RE: Montecito Ranch – SWMM Modeling Response to RBF

Major Stormwater Management Plan
(Major SWMP)

Project Name:	Montecito Ranch
Project Location:	
Permit Number (Land Development Projects):	TM 52510 RPL7
Work Authorization Number (CIP only):	
Applicant:	Montecito Ranch, LLC
Applicant's Address:	402 W. Broadway, Suite 1320 San Diego, Ca 92101
Plan Prepared By (<i>Leave blank if same as applicant</i>):	REC Consultants, Inc
Preparer's Address:	2442 Second Avenue San Diego, CA 92101
Date:	04-24-2013

- POC Map
- Typical DMA Map
- Typical Bioretention Cross Section
- Soil Distribution Map
- Overall Soils Map

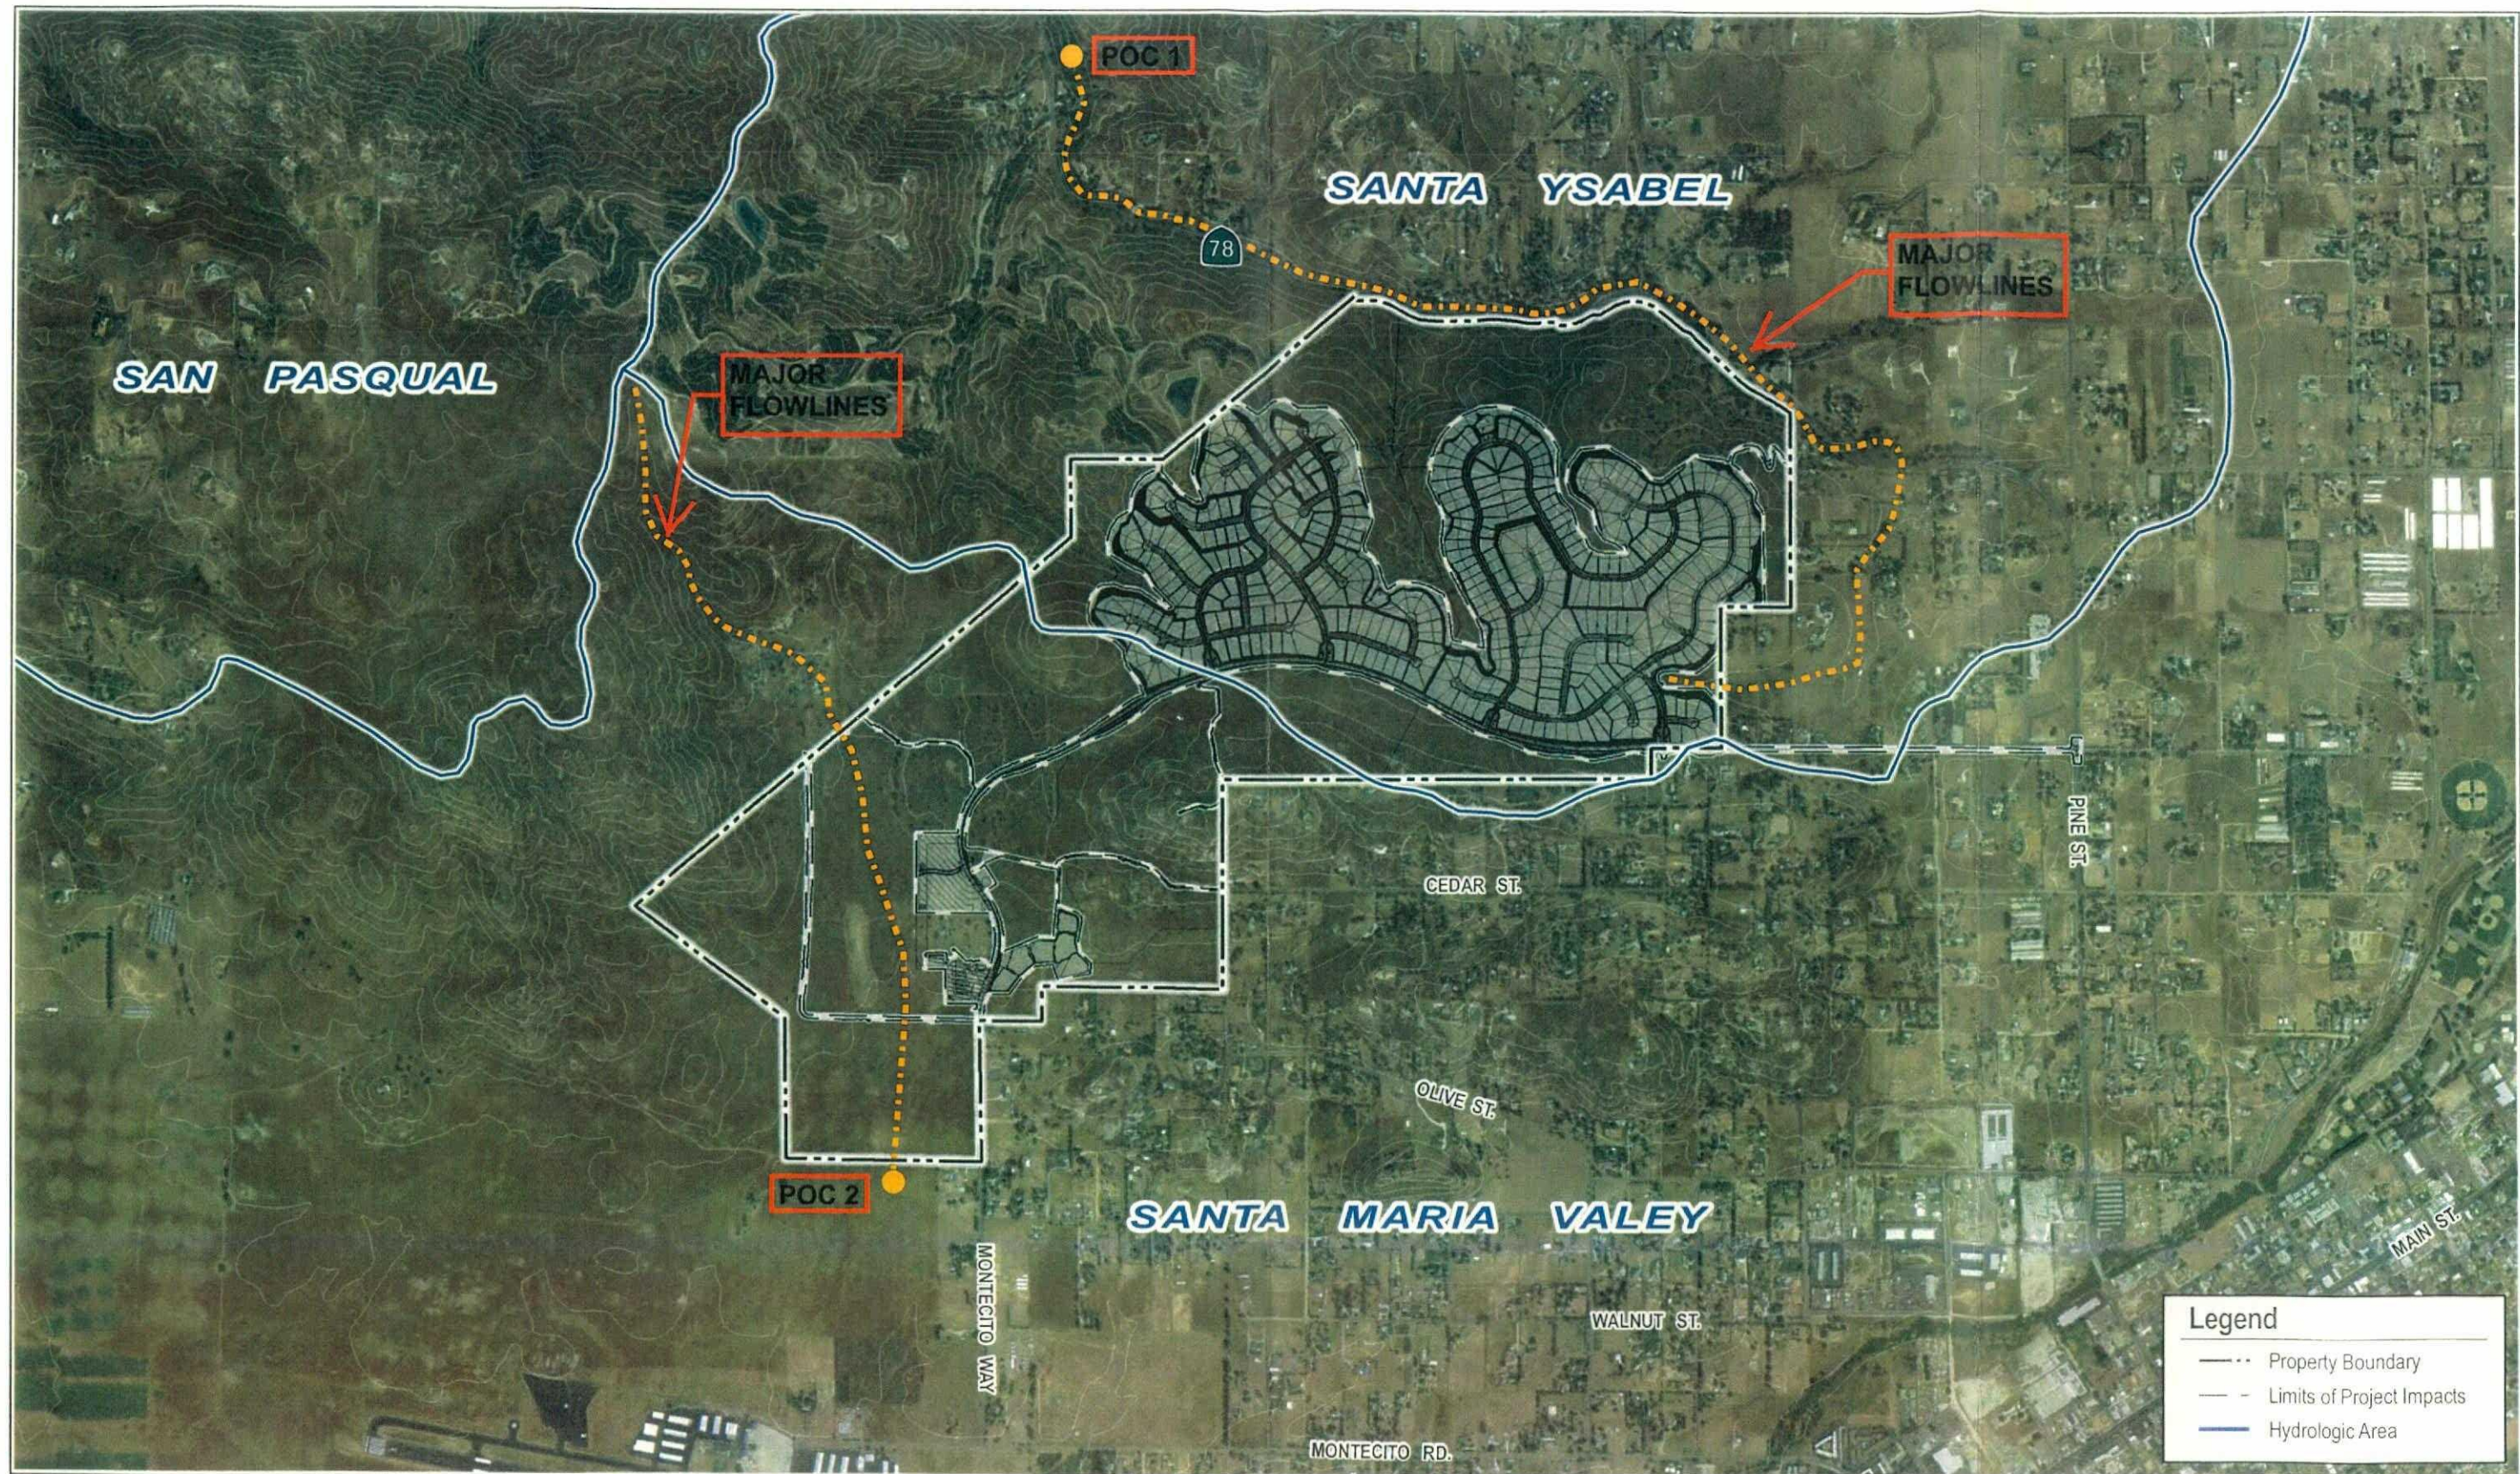
- *The report should discuss and graphically show the Point of Compliance (POC) for the analysis. The report should more specifically address the proposed improvements for Montecito Ranch Road and any required mitigation for HMP compliance. The majority of Montecito Ranch Road discharges to the southwest and does not appear to drain to the same POC as the residential portion of the development. An additional POC will likely be required.*

REC: Please see updated report for POC Map. There are two POC's, one to the north and one to the south. The SWMM model analyzes the Point Of Compliance to the north. The Brown and Caldwell Calculator was used to analyze the point of compliance to the south. See revised attachment H of the SWMP.

BIORETENTION AREA CROSS SECTION (TYP)

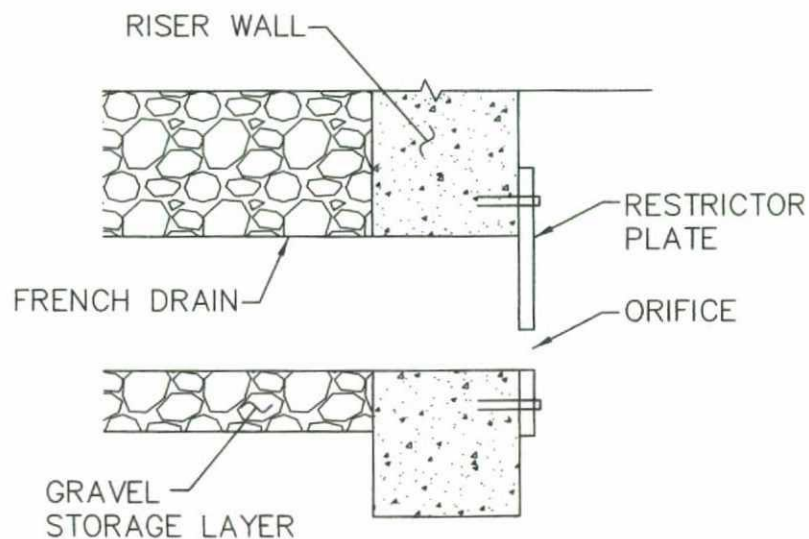
- *The detail and section in Attachment 6 are not consistent with the VTM or the Grading Plans. Either the plans or the calculations should be revised for consistency.*

REC: Plans will be updated for consistency
